**JORDAN VALLEY WATER CONSERVANCY DISTRICT  
2022 DISTRIBUTION PIPELINE REPLACEMENTS  
REDMAPLE AREA**

**ADDENDUM NO. 2**

Figure 1: Areas of new Distribution Pipeline in Redmaple Area

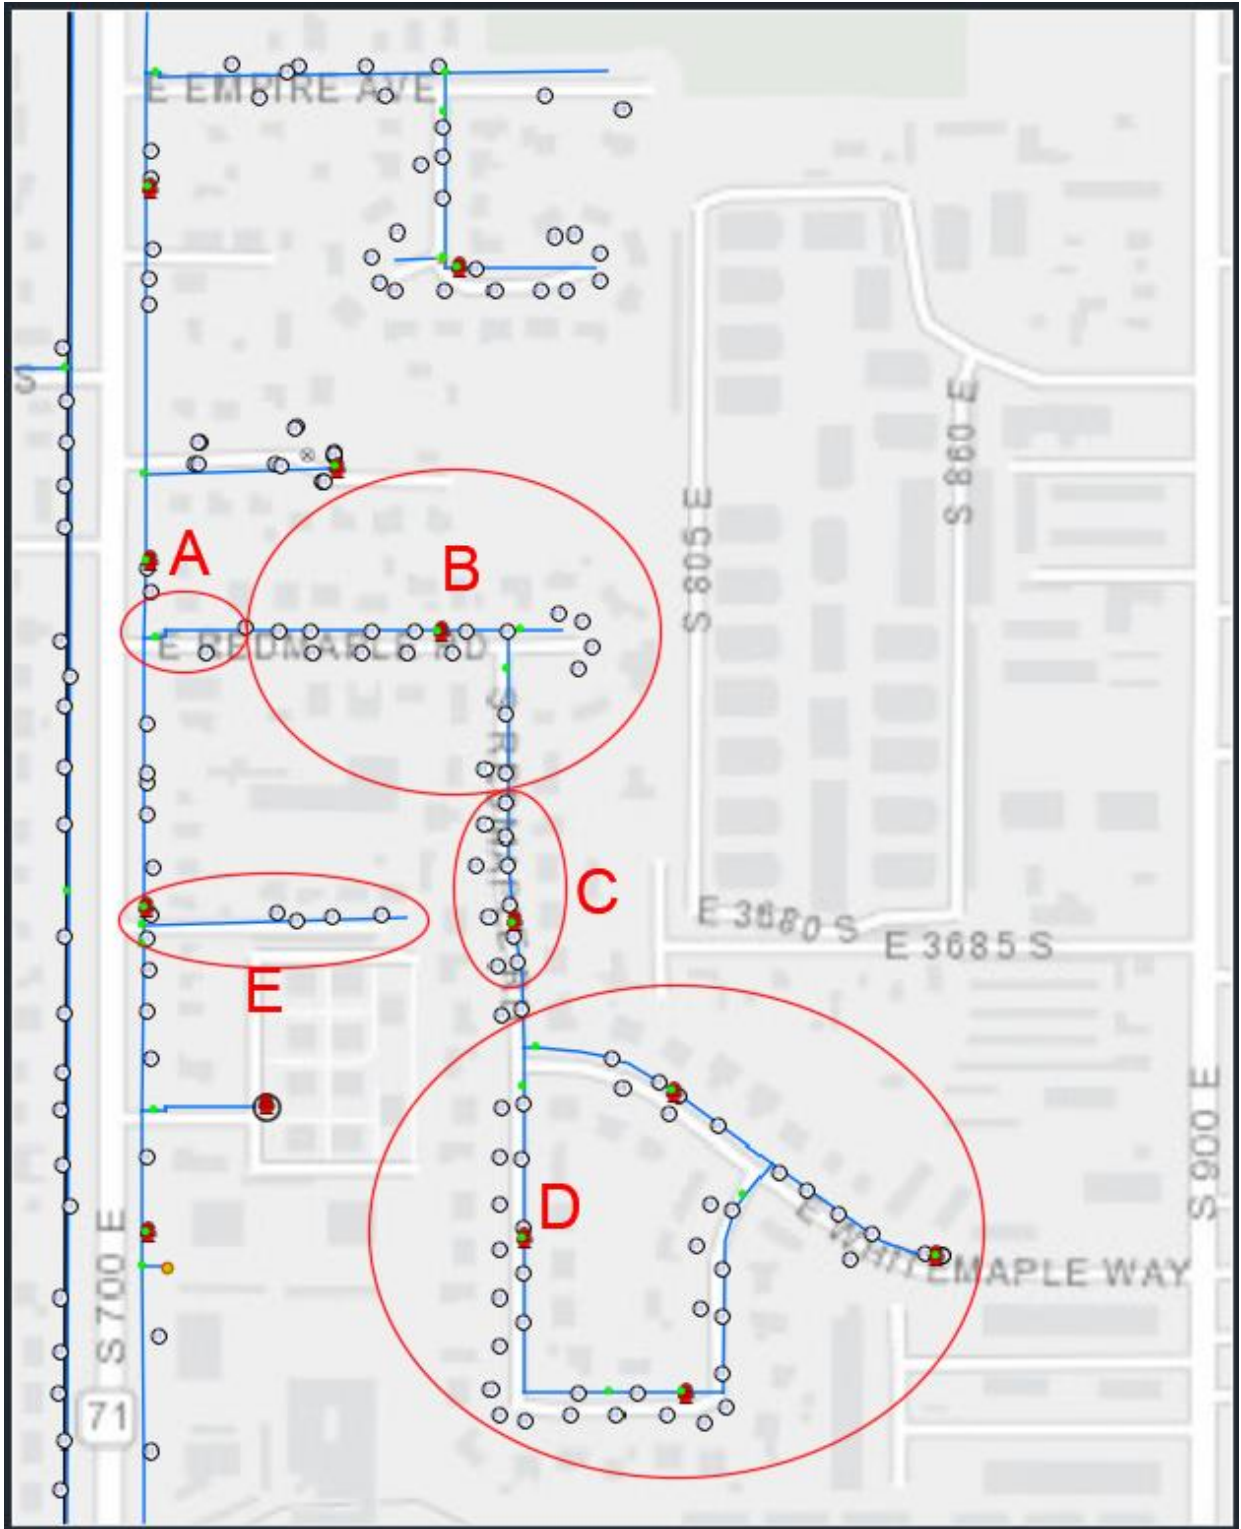
- 1. This addendum provides clarification regarding the temporary connections, temporary water, and bypass water required for this project. This provides an overview of how these are to be staged for the project. Contractor may suggest alternative ideas once project begins. Please see Figure 1 in this addendum for overview map and locations of specific zones referred to in this addendum.

- 2. The zones on Figure 1 refer to the zones affected by temporary connections. Note that Empire Ave, Empire Circle, and 3720 South have no temporary connections with this project.
  - A. In Zone A on Figure 1, a temporary connection is required as seen on Drawing PP-4 and Detail 5 on Drawing D-1. This connection is to be constructed in conjunction with Detail 4 on Drawing D-1. This work will need to be completed within a 6-hour waterline shutdown period.

- B. Zones B, C, and D will receive water from the existing 6" cast iron pipes via the temporary connection (Detail 5, Drawing D-1) as construction continues.

- C. The work in Zone B should proceed next. This includes Redmaple Road from the temporary connection in Zone A to the end of Redmaple Circle, plus the Redmaple Road running North/South from Station 11+90 (PP-8) to about Station 9+10 (PP7). This section, up to the new hydrant and gate valve on PP-7 and Detail 8 on D-2 shall be flushed and tested, placed in service, and connected to service laterals prior to the work in Zones C and D.

- D. Once the work in Zone B is in operation, the new hydrant located near Station 9+40 can be used to provide temporary water downstream. The meters called out by Keyed Note 1 on PP-7 are to receive temporary water. Zone D shall receive water via a temporary bypass referred to in specification 02565-2 paragraph 201.01.C and called out on Keyed Note 2 of PP-7. Thus, Zone D shall receive water in the existing 6" cast iron pipe via

this temporary bypass while work continues. Once Zones C and D are receiving bypass water, the temporary connection in Zone A can be isolated and work can commence in Zone C. The existing pipelines in Zone C must be abandoned prior to laying the new piping in its place.

- E. Zone D can continue to receive water via the bypass until all new construction in Zone D is complete, flushed, tested, and all services are tied into the new pipelines.
- F. Zone E, 3680 South, also receives temporary water as specified in Keyed Note 1 on PP-13 and specification 02565-2 paragraph 201.01.C.
